# PLANNING BOARD MEETING

c. Project: Site Plan – Dandy Mini Mart – Convenience (Mini) Mart

This is our response to the comments provided on June 10, 2022, for the above-referenced project. The following is an item-by-item response, numbered in accordance with your original comments.

**EXISTING  
CONDITIONS**  
**C2**

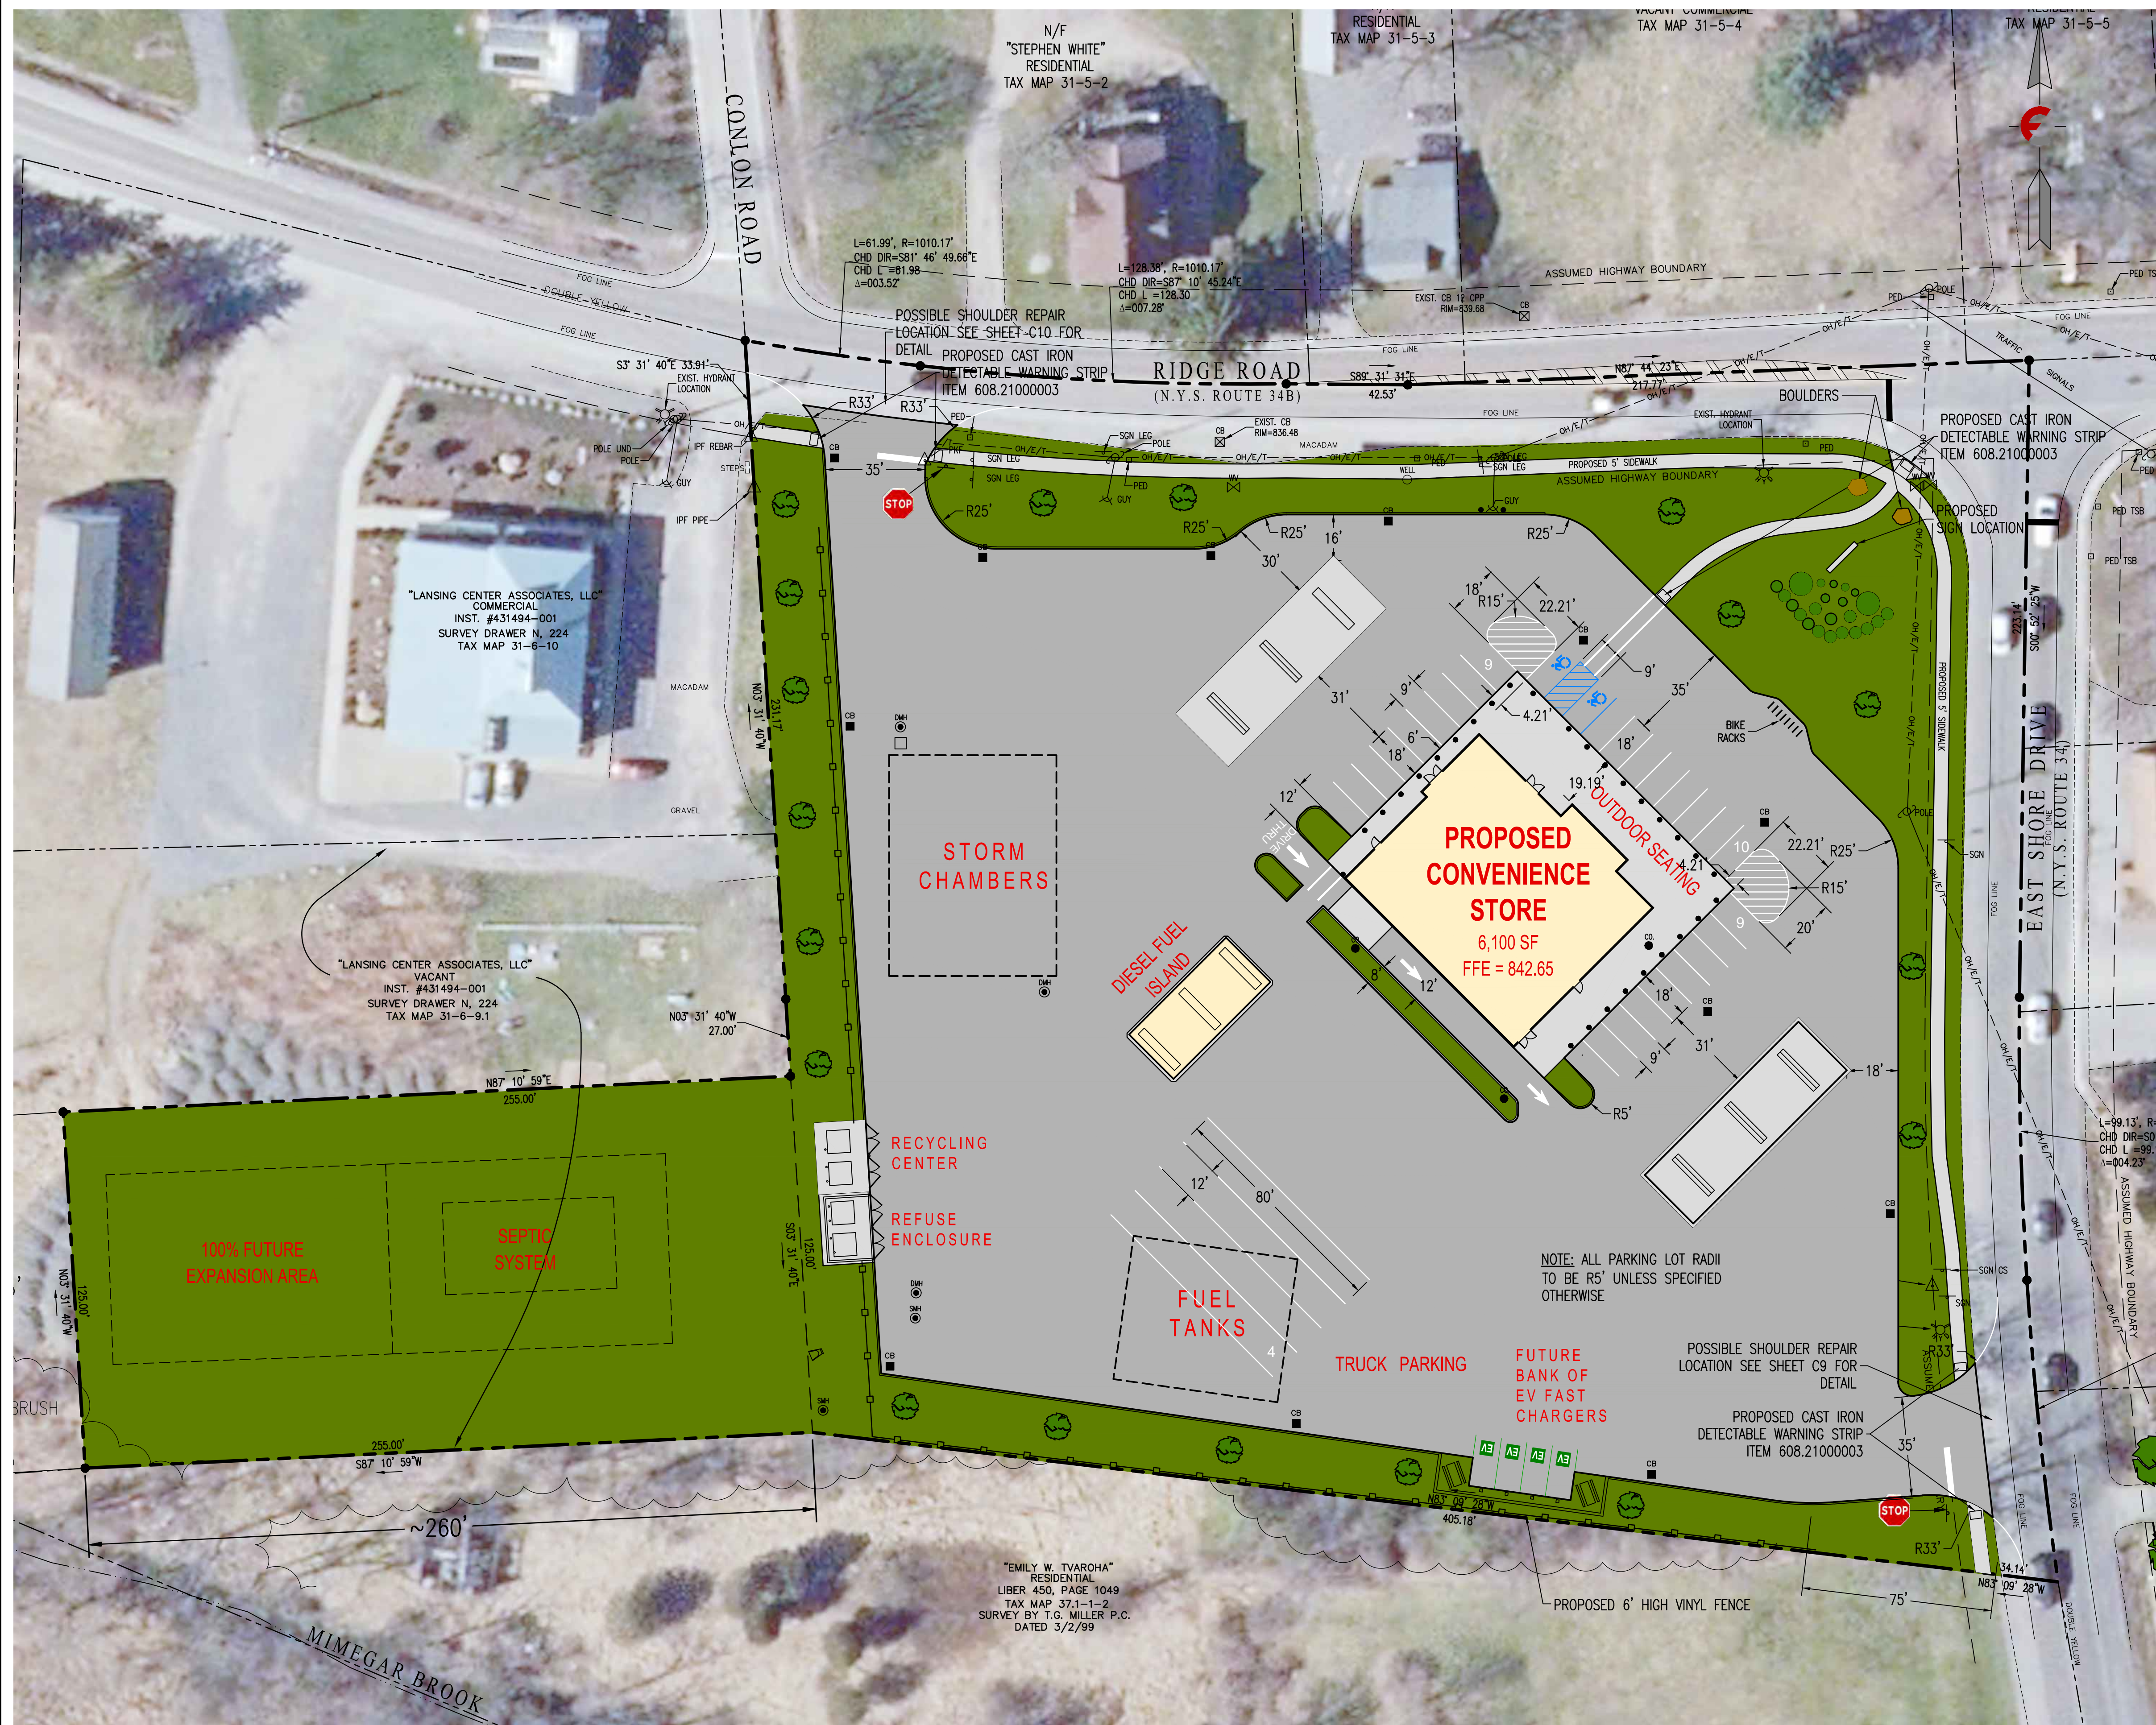
*C2 All plan sheets detail the “assumed highway boundary”. This should be surveyed and determined to be the actual highway boundary, not assumed.*

**R9: There is only existing curb line at the intersection of NYS Route 34 and NYS Route 34B. This curb line can be seen on Plan Sheet C2. The curb line will remain in place except for the proposed ramp area for the proposed sidewalk. The curb line will transition down into a 1" reveal at this location.**

**C4**

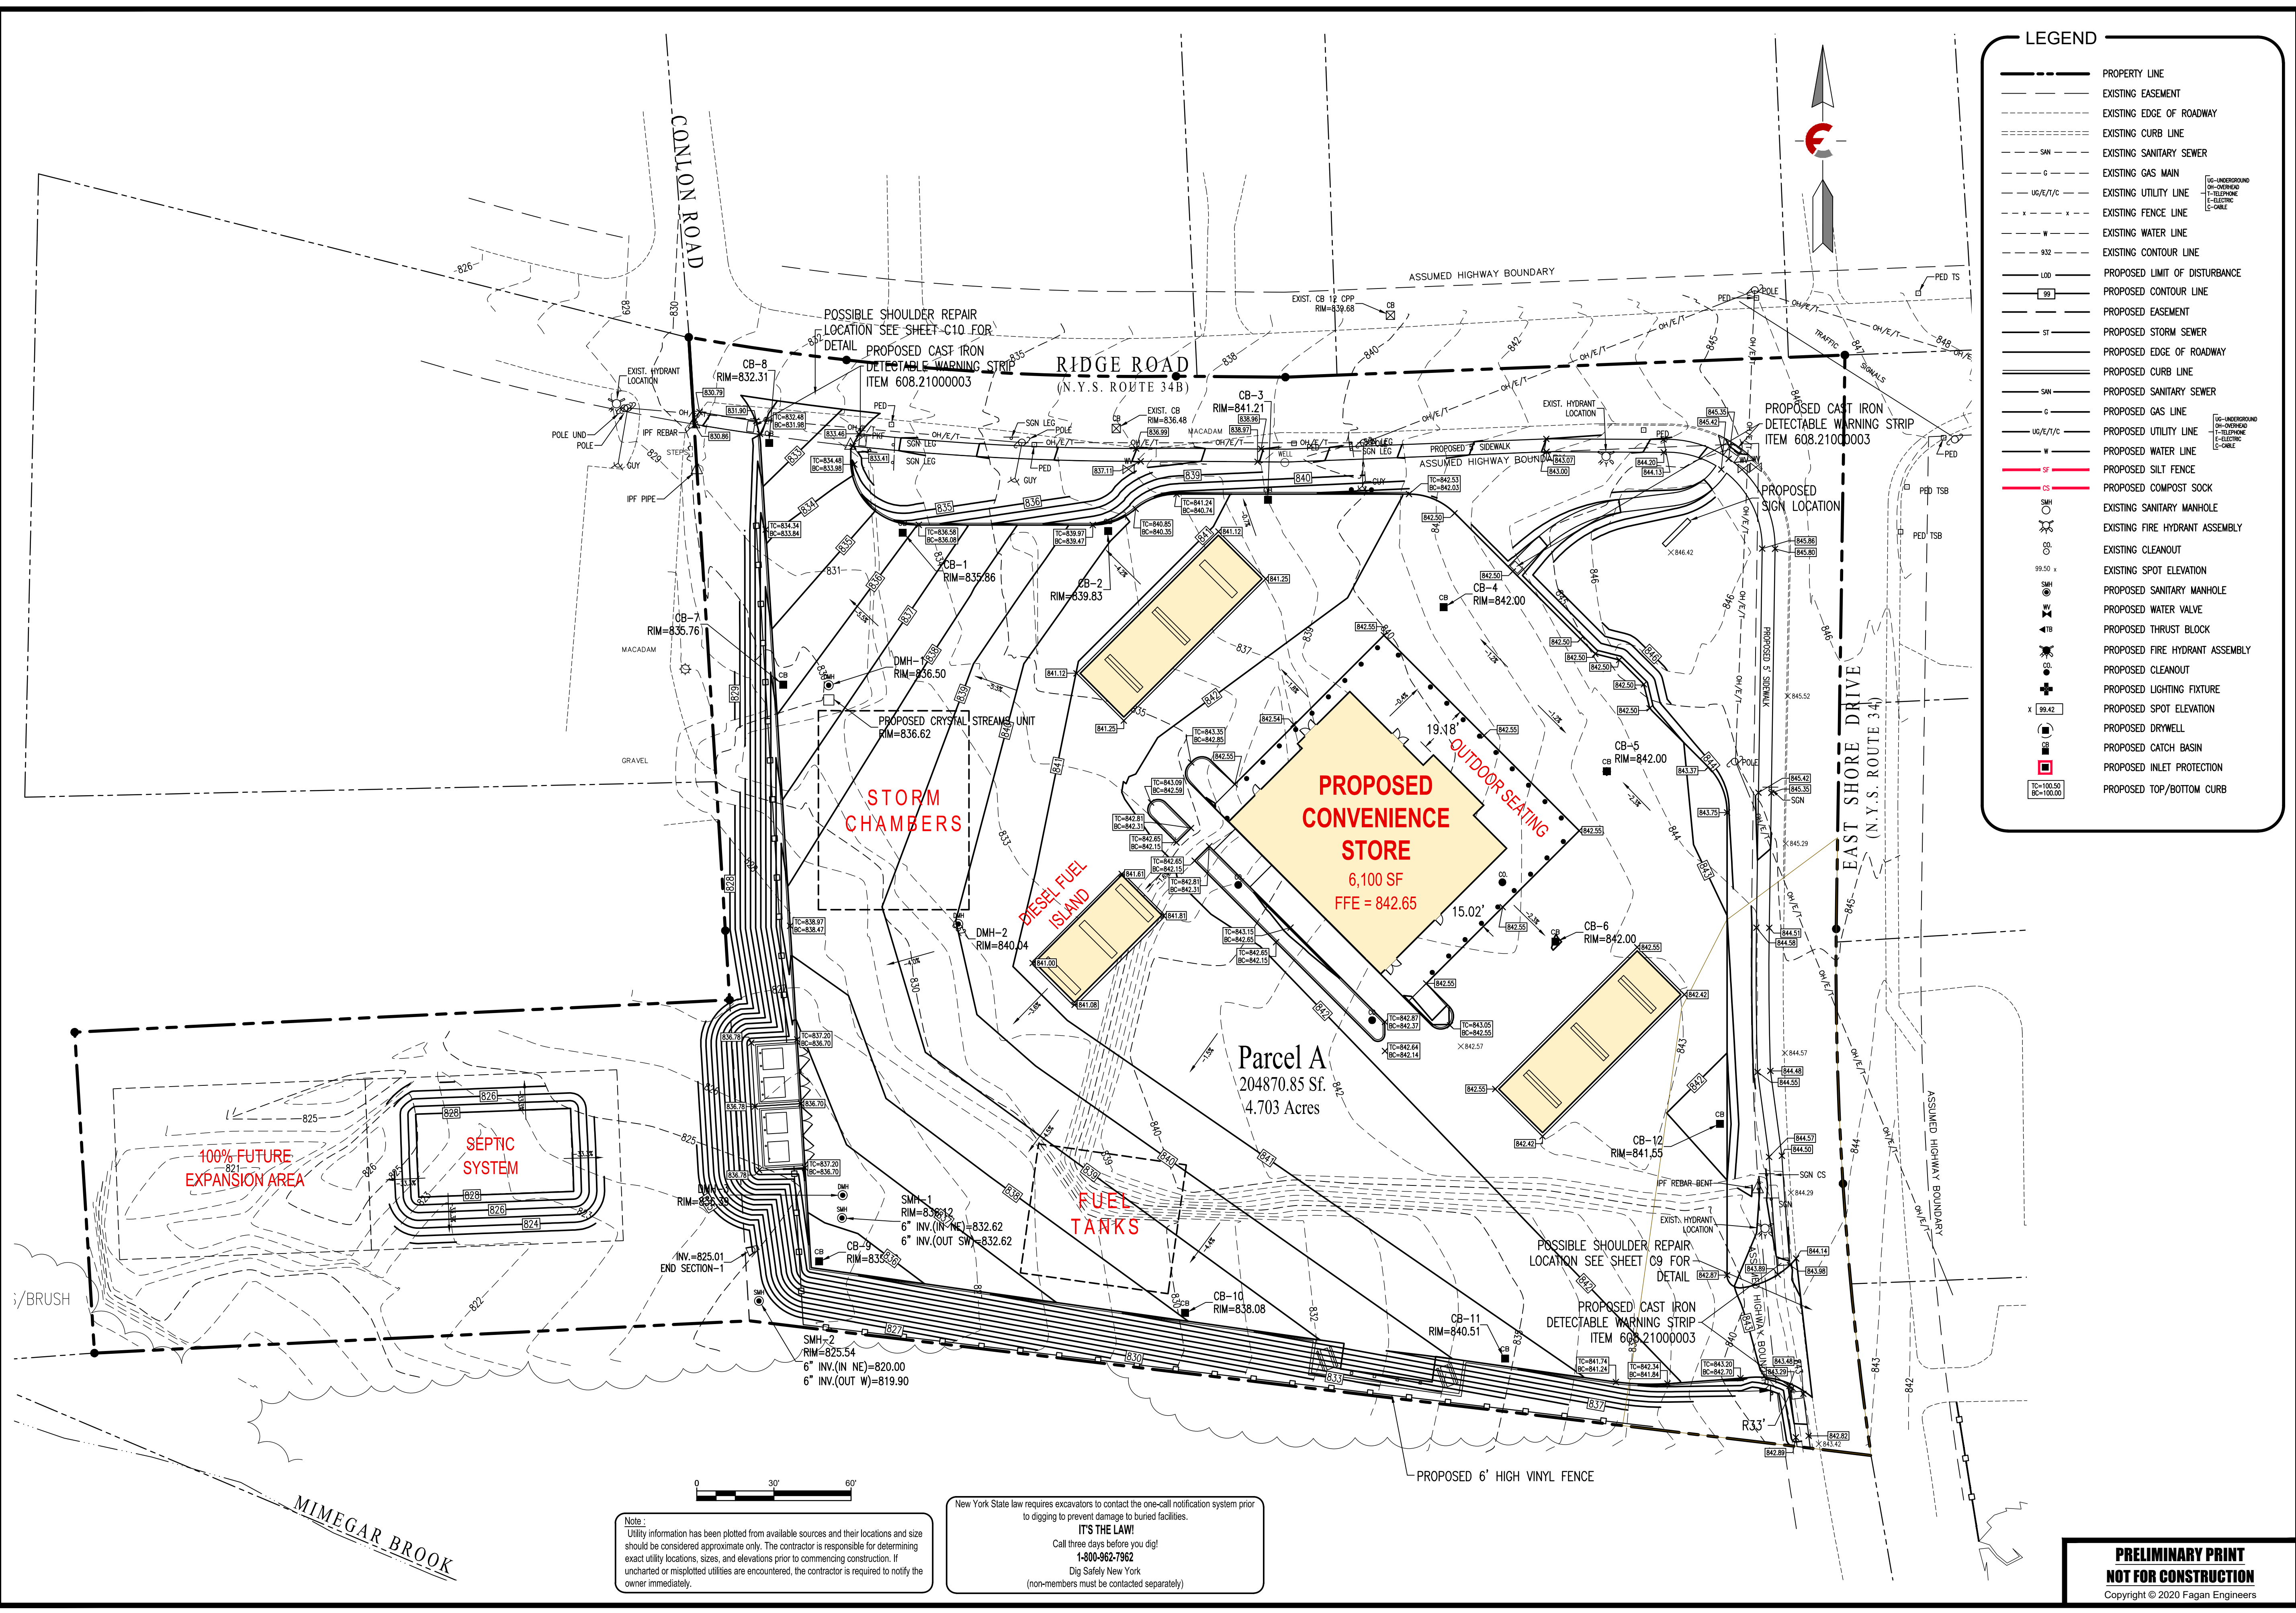
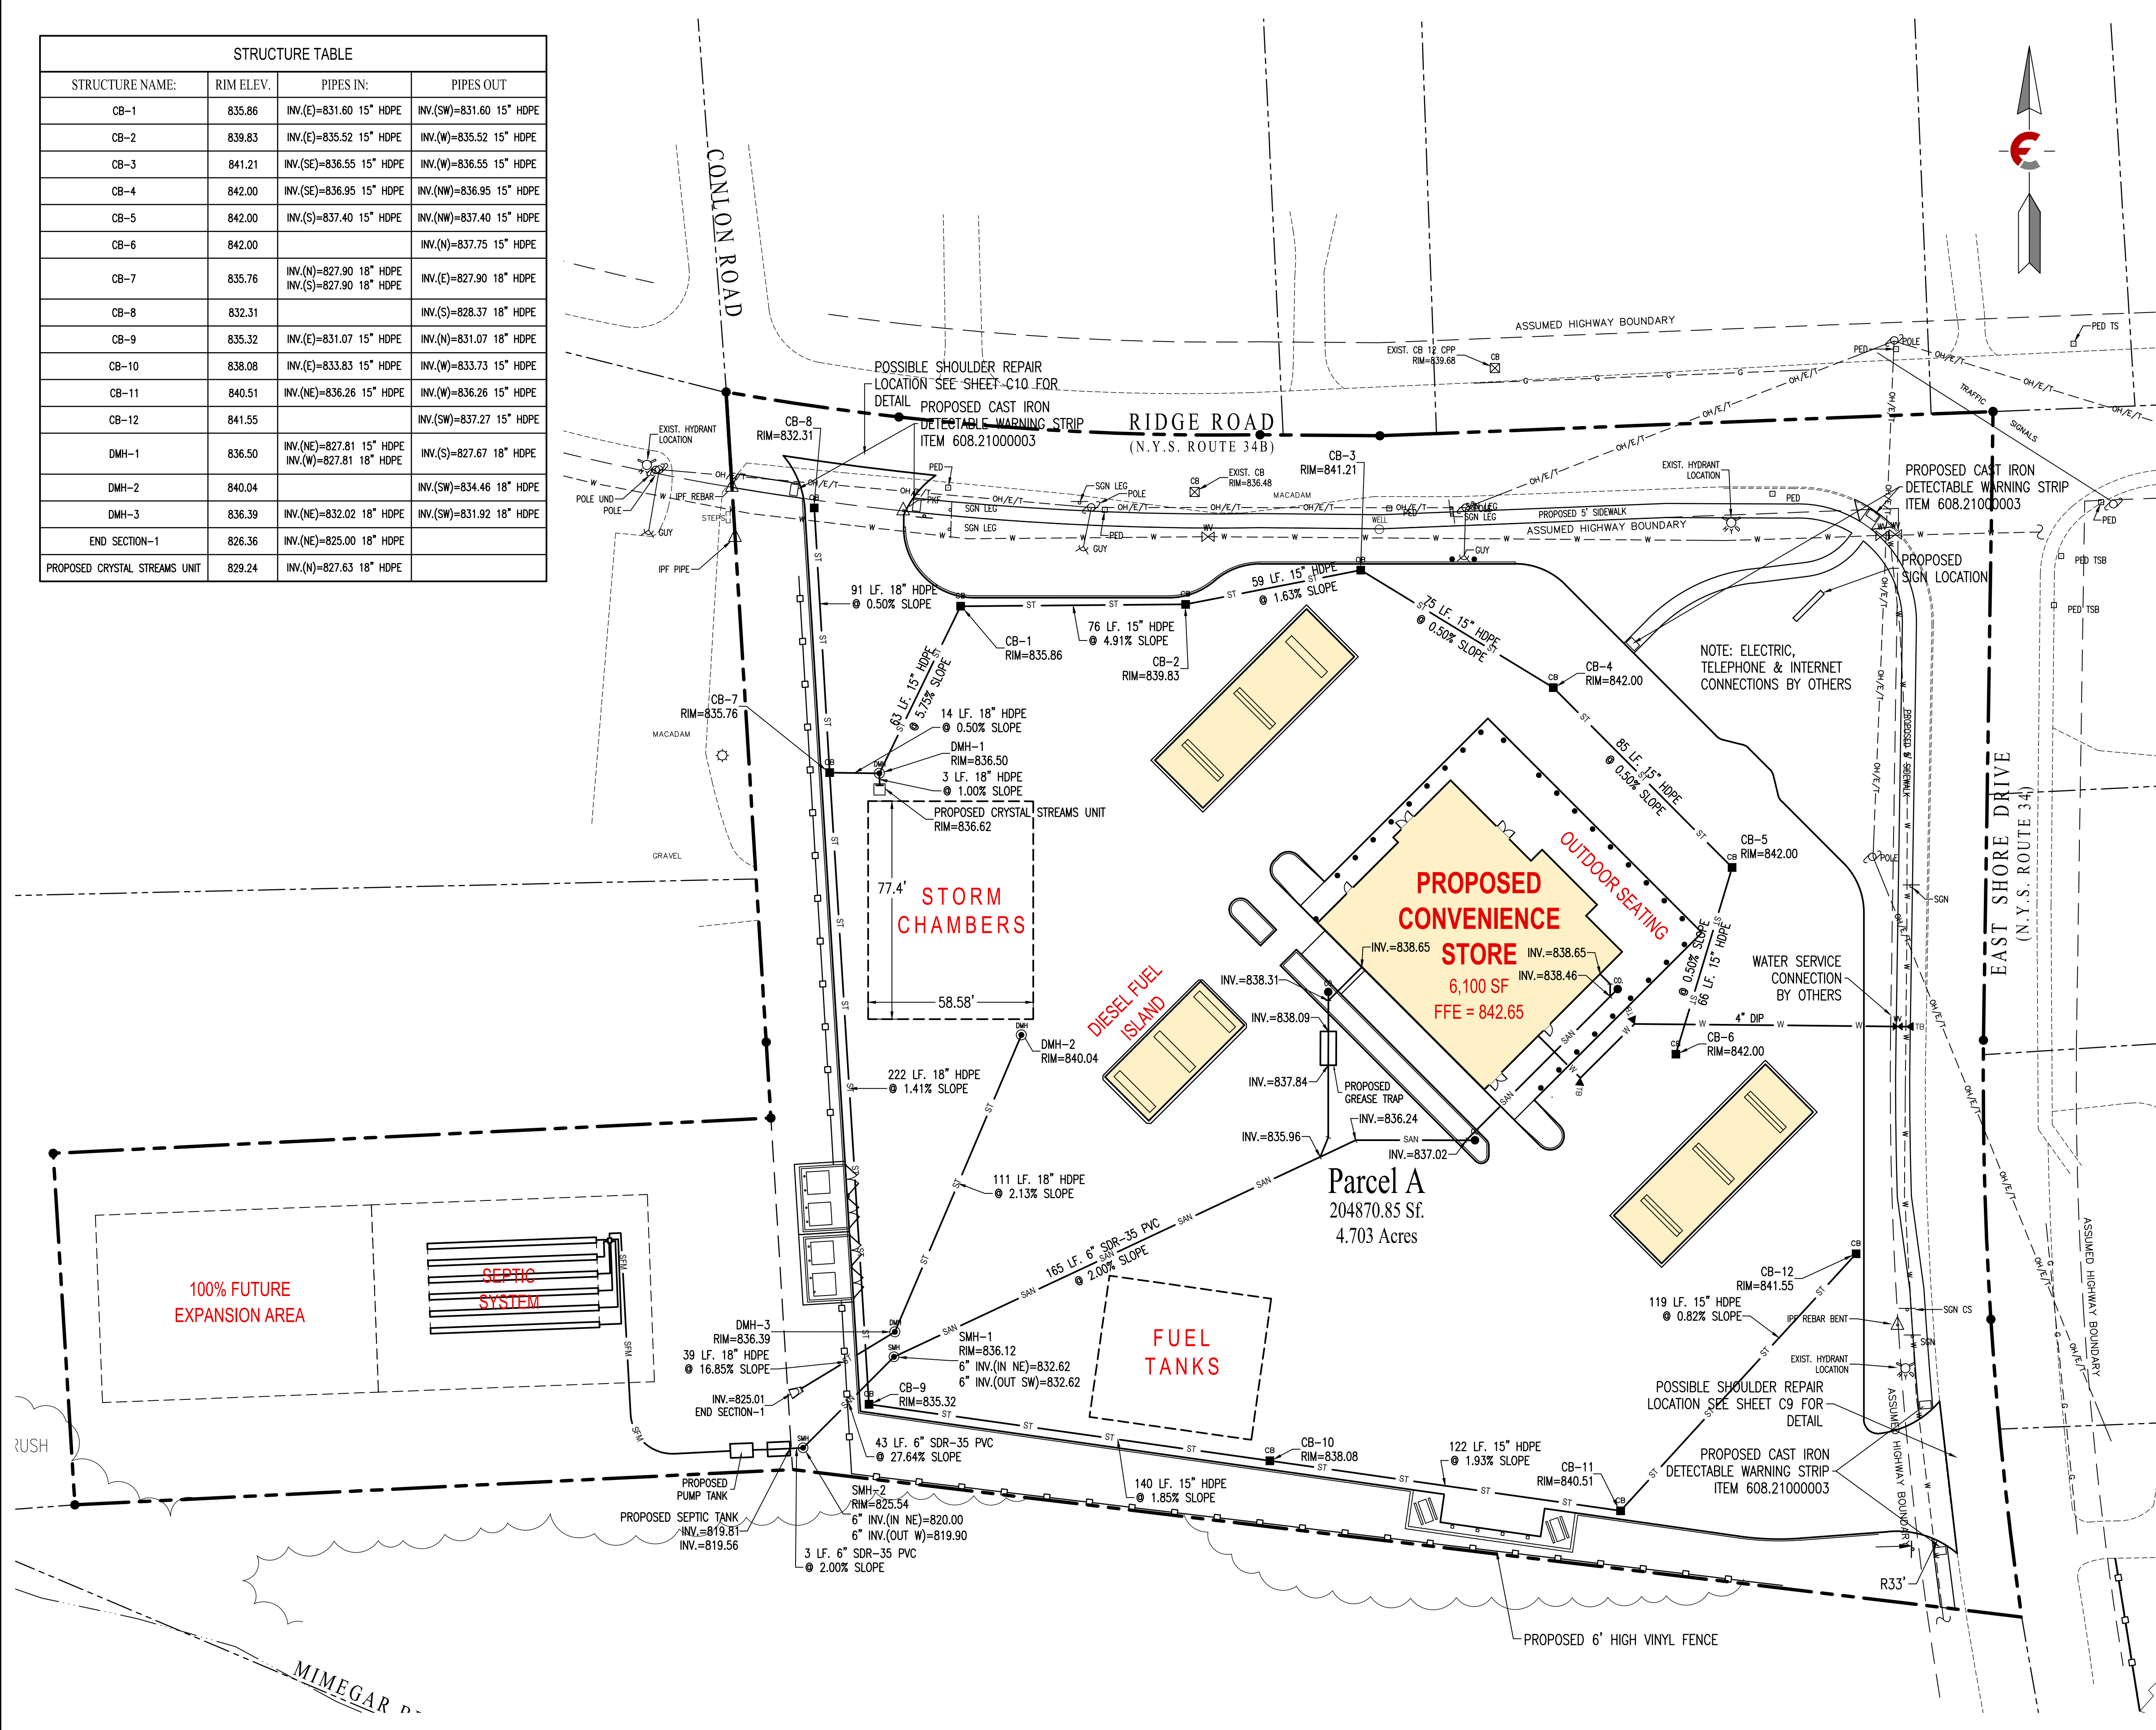
*C4 I didn't really see any inflows or outflows clearly shown on the plans for the storm storage area. Just into and out of the storage area itself. There was one spot it looked like it was there intent but I didn't see it called out.*

**R1 Please see revised Plan Sheet C4 for updated grading that has been kept out of the NYS ROW, relocated curb line, and relocated CB-3 to be outside the existing waterline path.**

**R4: Please see revised Plan Sheet C4 for added grading.**
